**INDUSTRIAL DRIVE ATHLETIC FIELDS AND
DAWSON RECREATION IMPROVEMENTS
HOLDEN, MA**

ADDENDUM NO. 4

CONSTRUCTION DOCUMENTS

March 8, 2024

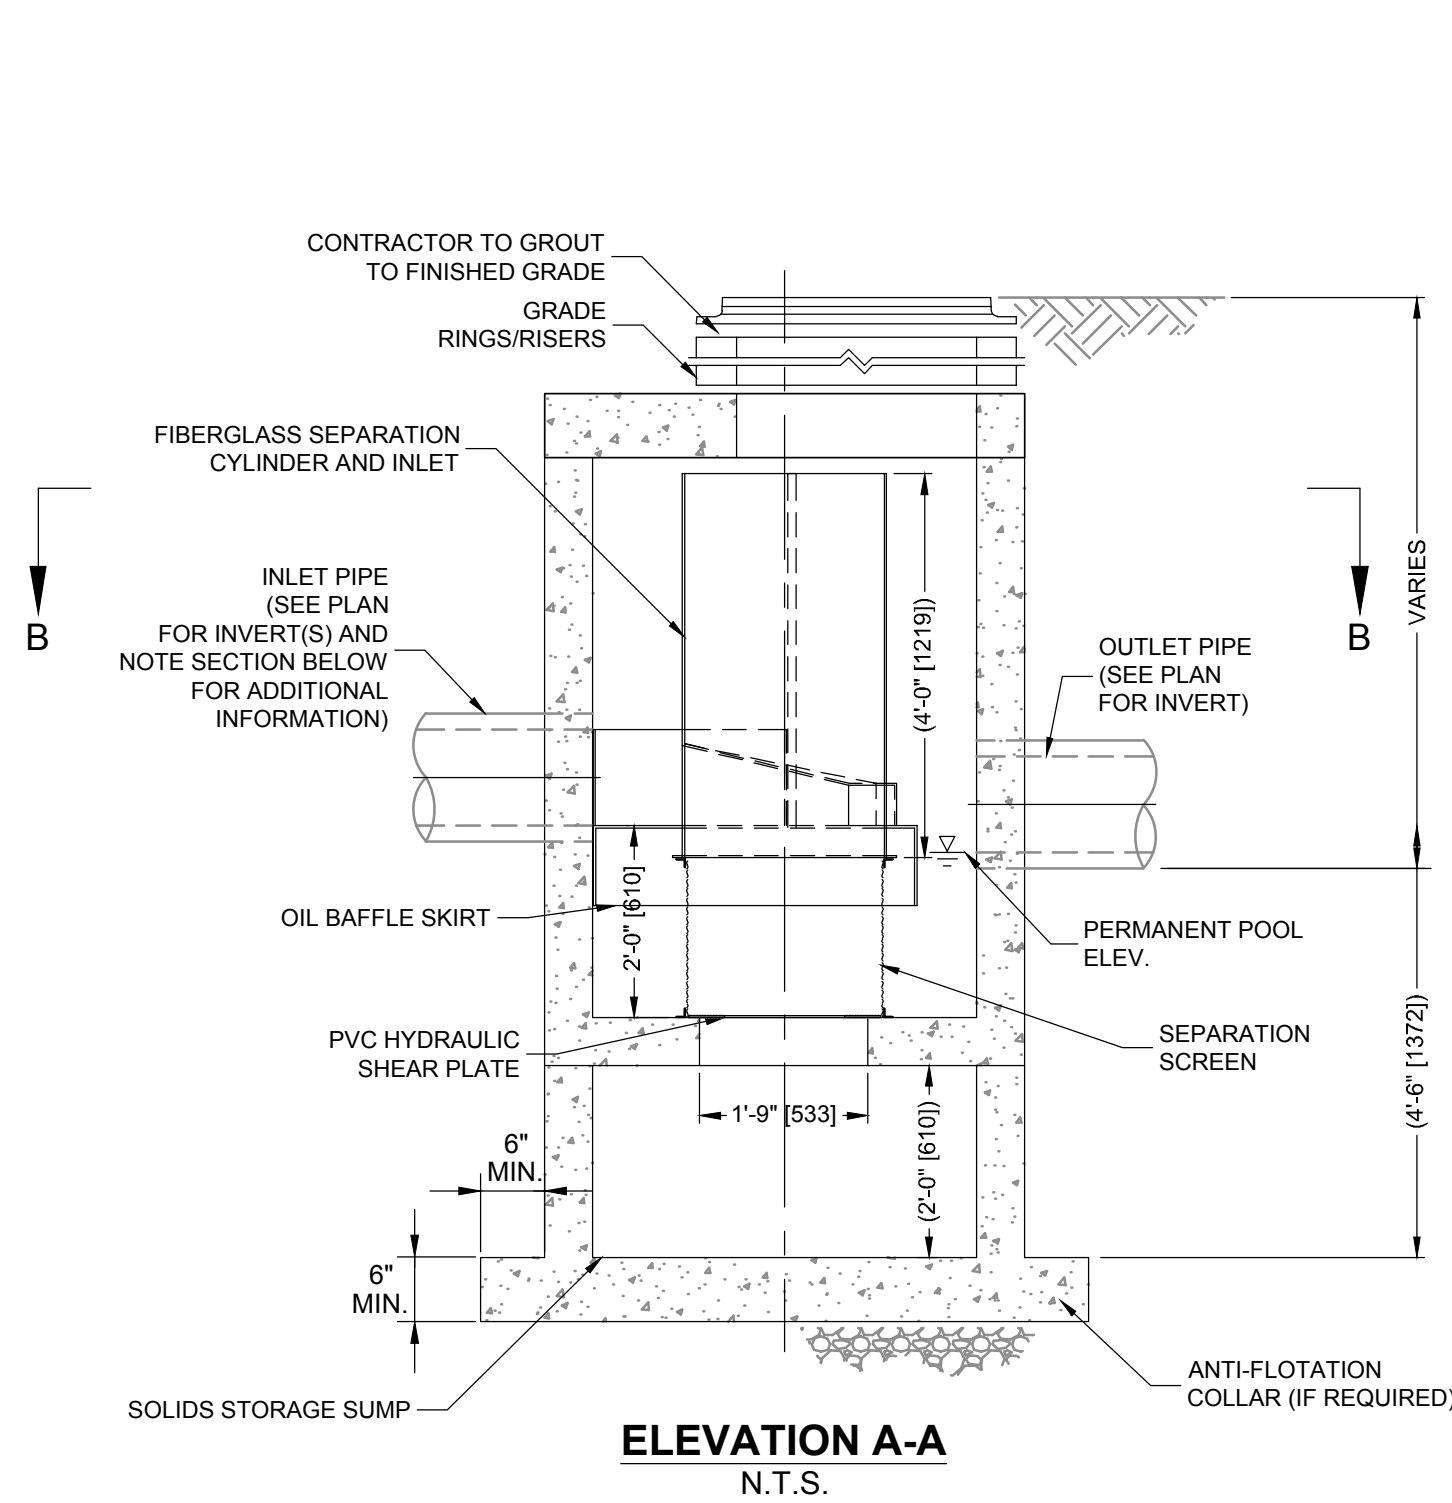
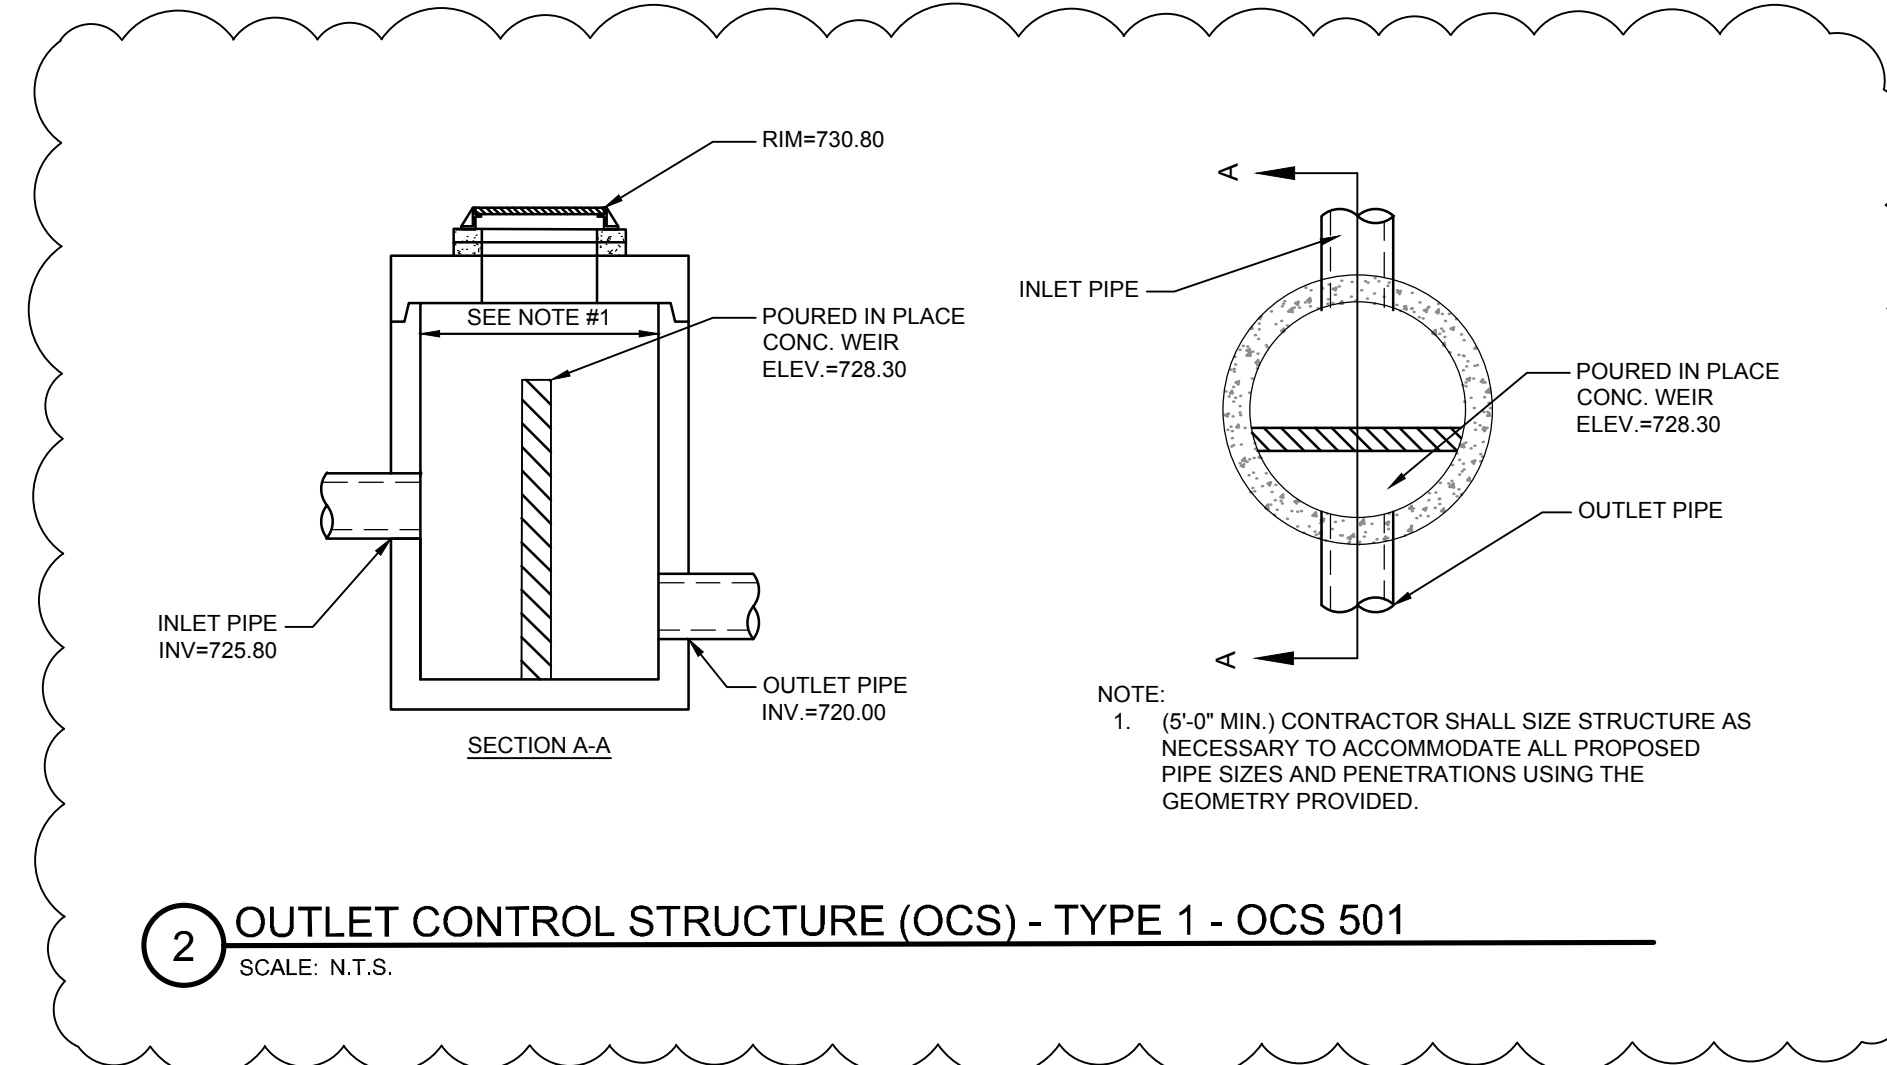
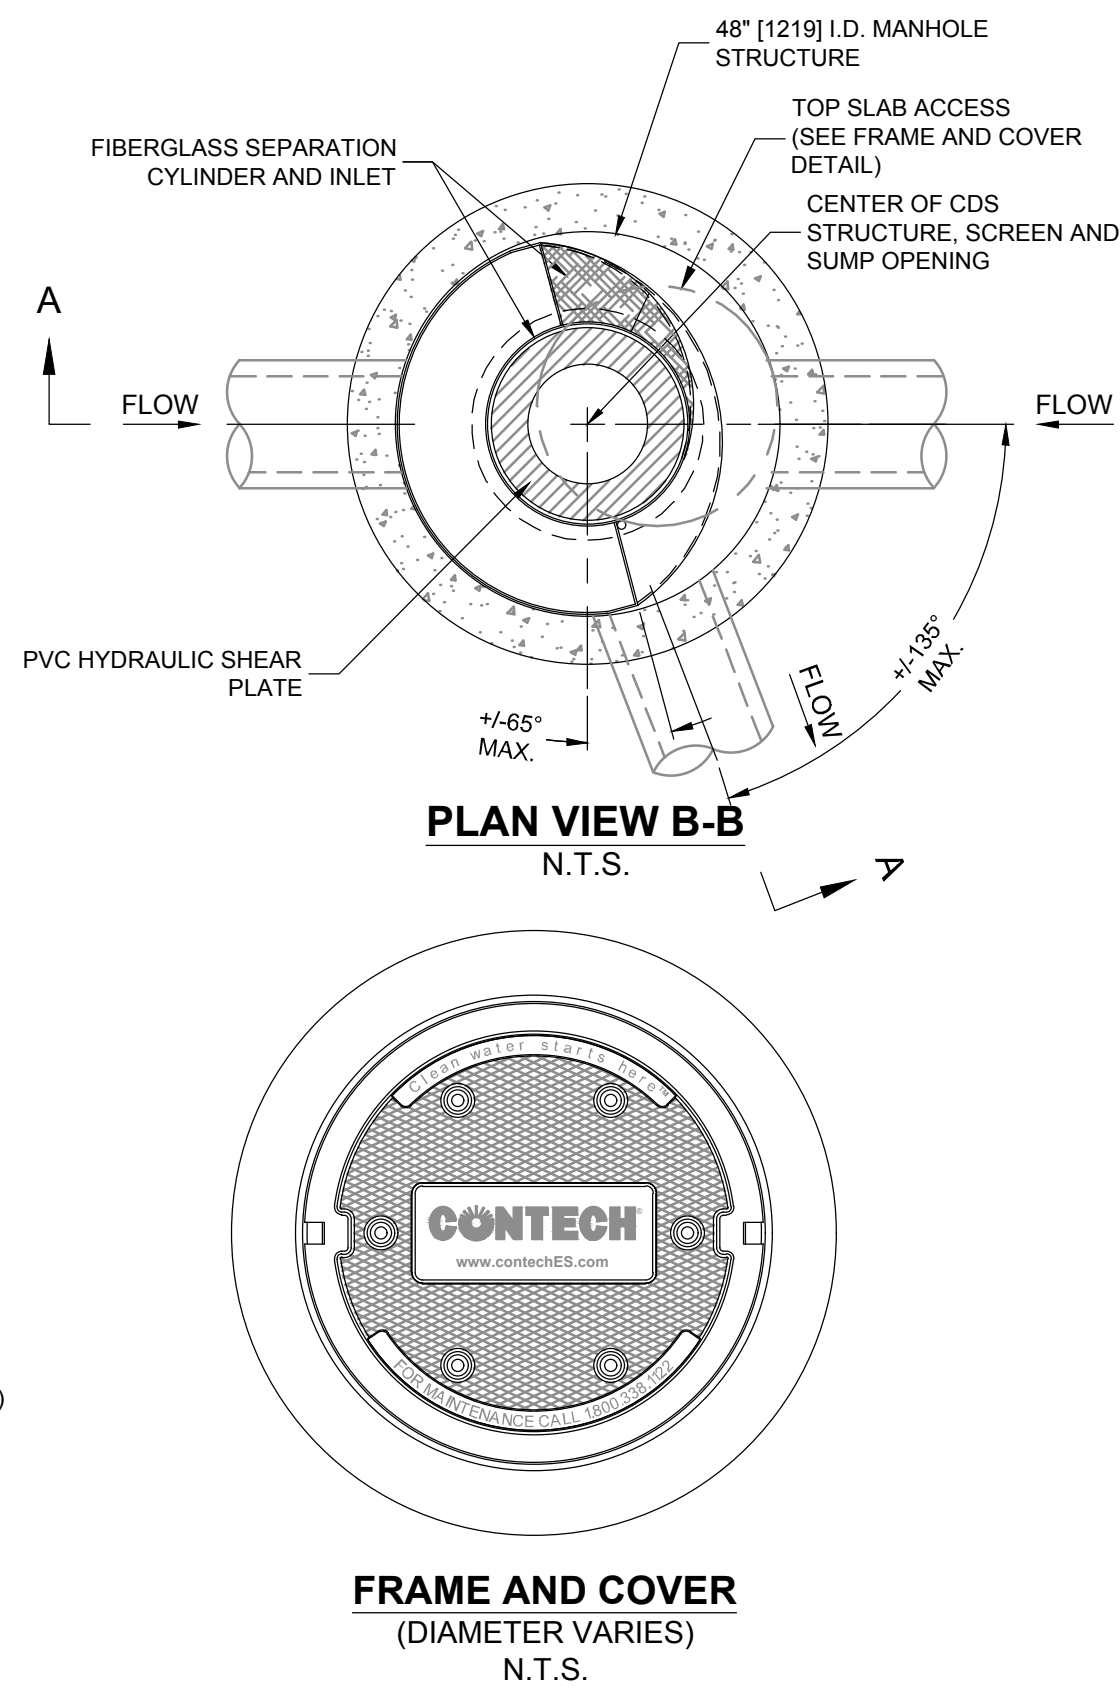
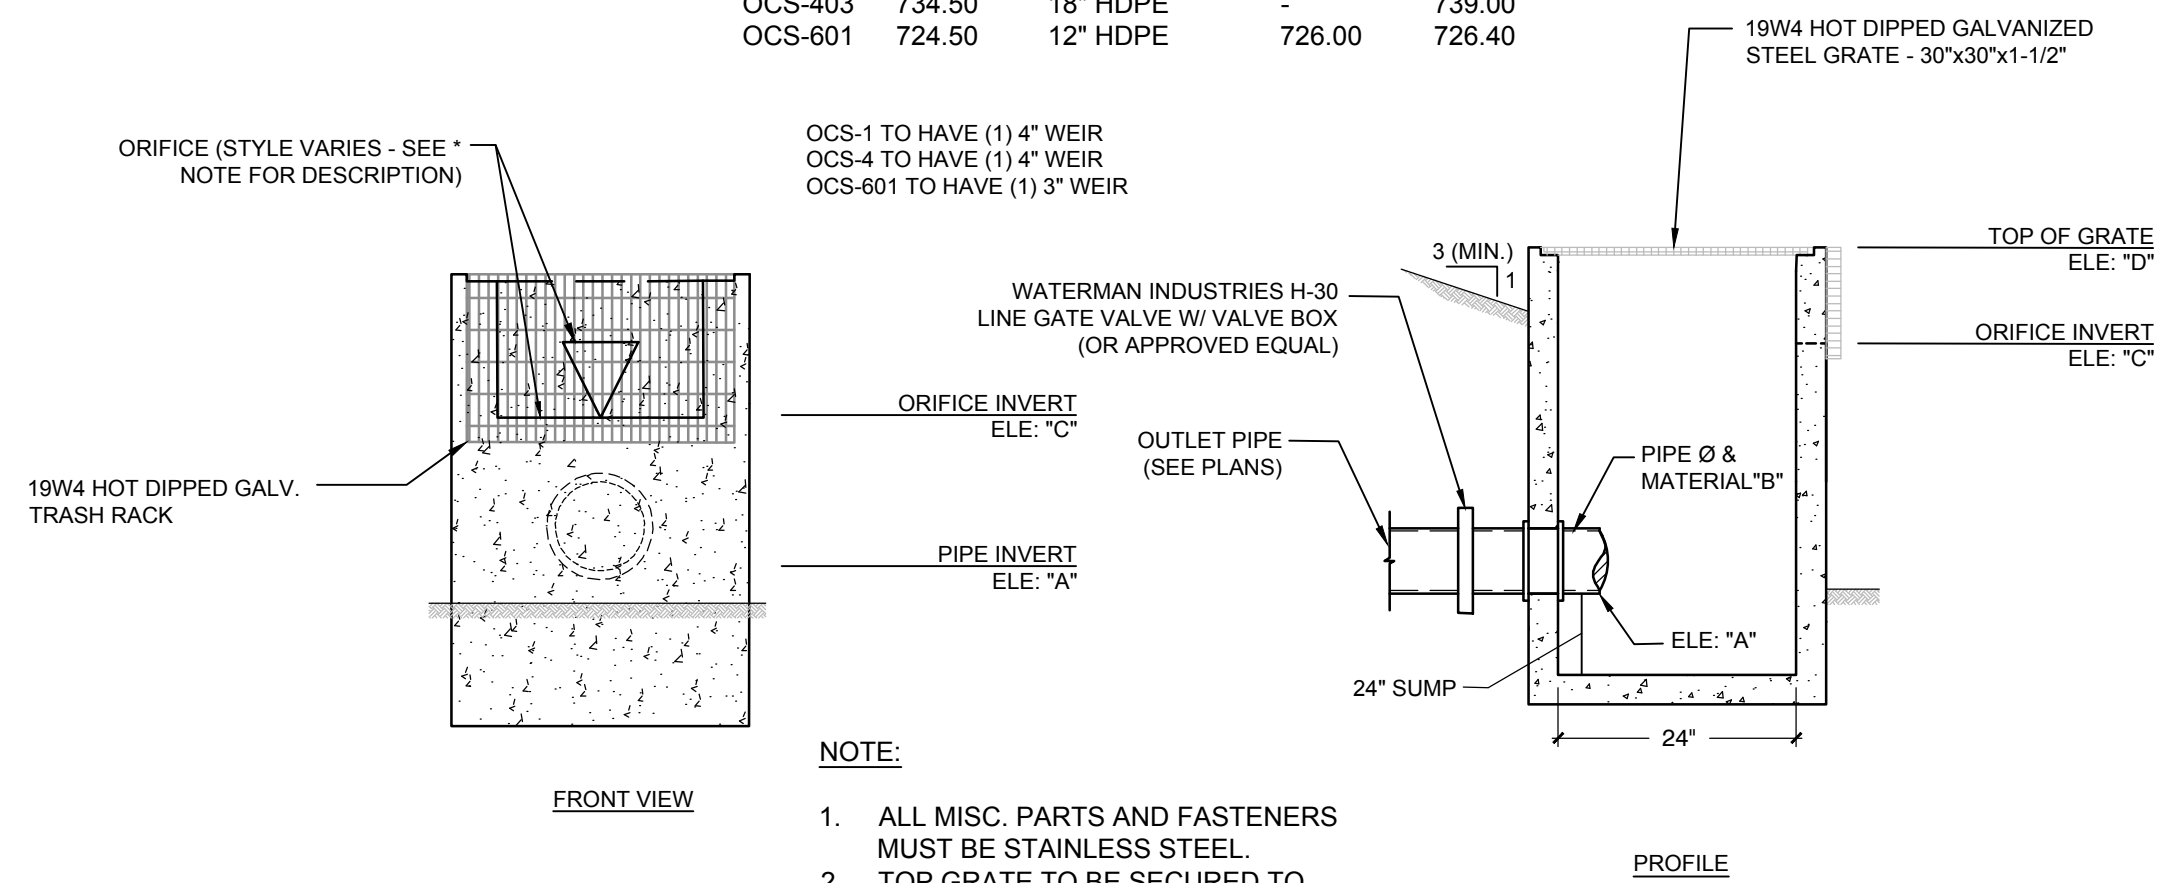
3. **DELETE:** Sheet UT702 – DRAINAGE & UTILITIES DETAILS

ADD: Sheet UT702 – DRAINAGE & UTILITIES DETAILS, per attachment
